Proposal for Constellation Re-arrangement in IR HARQ

IEEE C802.16m-09/0124

Target section: 11.13.2.2 Bit re-arrangement

Problem of Current Co-Re Operation

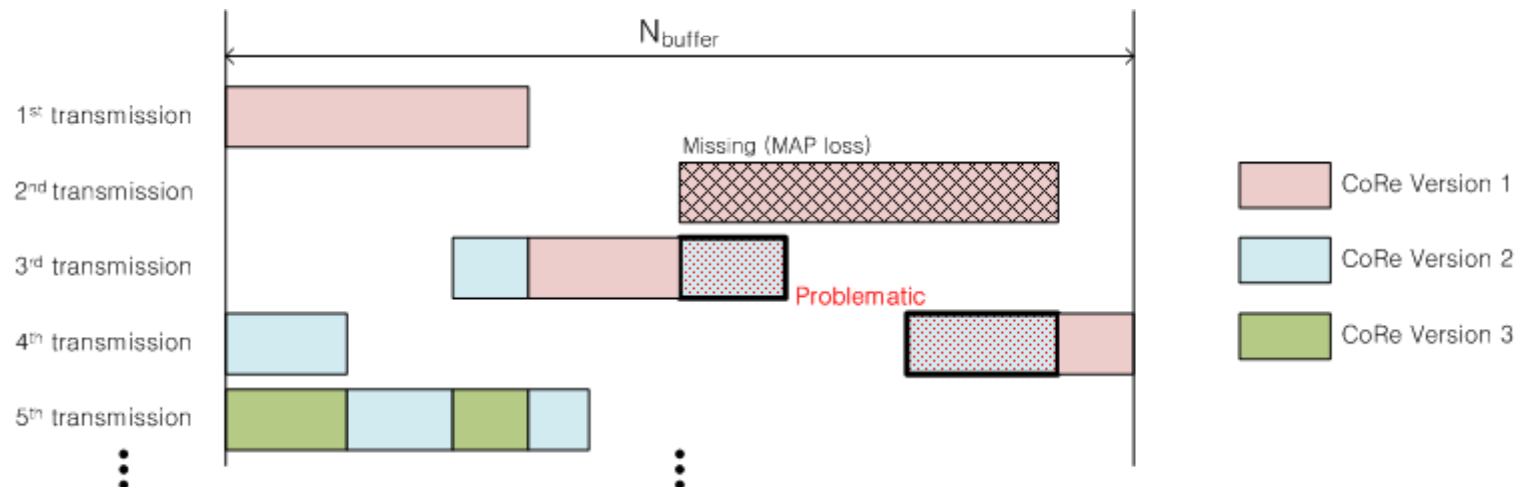
- Current Co-Re operation has a problem in case of IR-HARQ and adaptive HARQ.
 - If the MAP is missing, the MS can't know the CoRe-version for each transmitted bit.
 - In IR and adaptive HARQ operation, this problem is critical.
 - For each transmitted symbol, the CoRe-version may be indicated, but the overhead is large.

Proposed Co-Re Operation

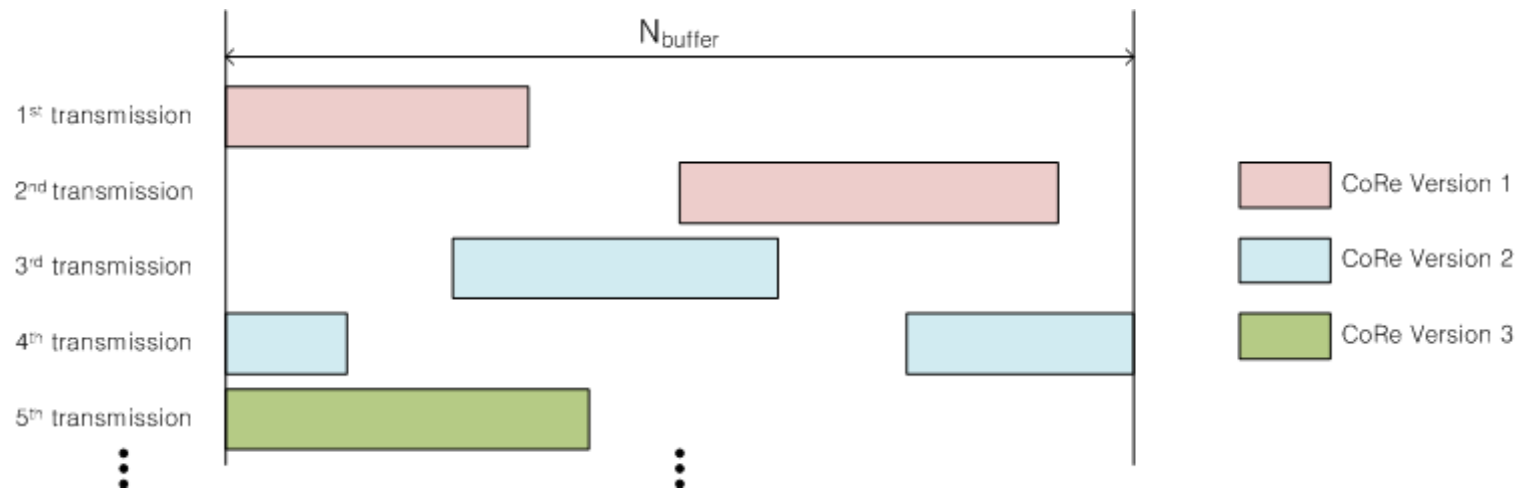
- In the proposed scheme, all the modulated symbols in a HARQ re-transmission use same CoRe-version.
 - Robust Co-Re operation in case of MAP loss
 - Minimal overhead for CoRe operation
